REPORT ON REFURBISHED AND MODIFIED INDOOR DECK LEVEL SWIMMING POOL, SPA AND ASSOCIATED WORKS

**Emerald Quay
Shoreham-by-Sea
West Sussex
BN43 5JP**

Report prepared by Ian Betts BSc CEng MICE FISPE MCIWEM MCM

Plate 1 : Overflow weir with single slot

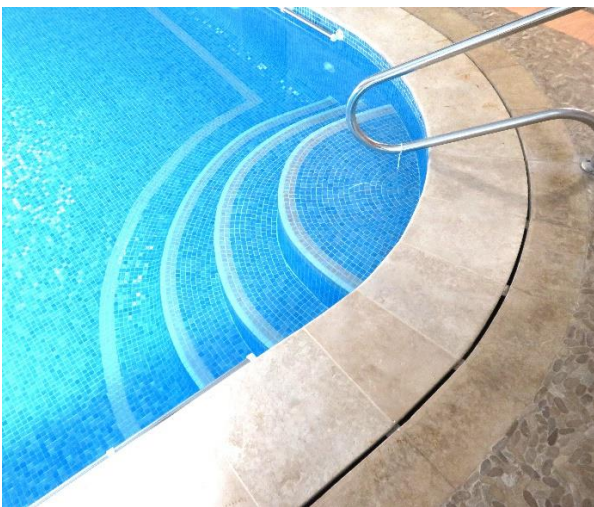
The channel overflow weir tile is some 300mm wide and new rear edge tile some 200mm wide was provided. The overflow weir tile was supported over the channel on metal supports and the overflow water was circulated through a single slot (see Plates 1 and 2).

The overflow weir tiles have been fitted permanently and does not allow for any access to the channel for cleaning or general maintenance or for access to the automatic water top-up control which is in the channel.

Note: The overflow slot at the channel is some 14mm wide (see Plate 2) which is considered a toe entrapment hazard (maximum opening allowed is 8mm)
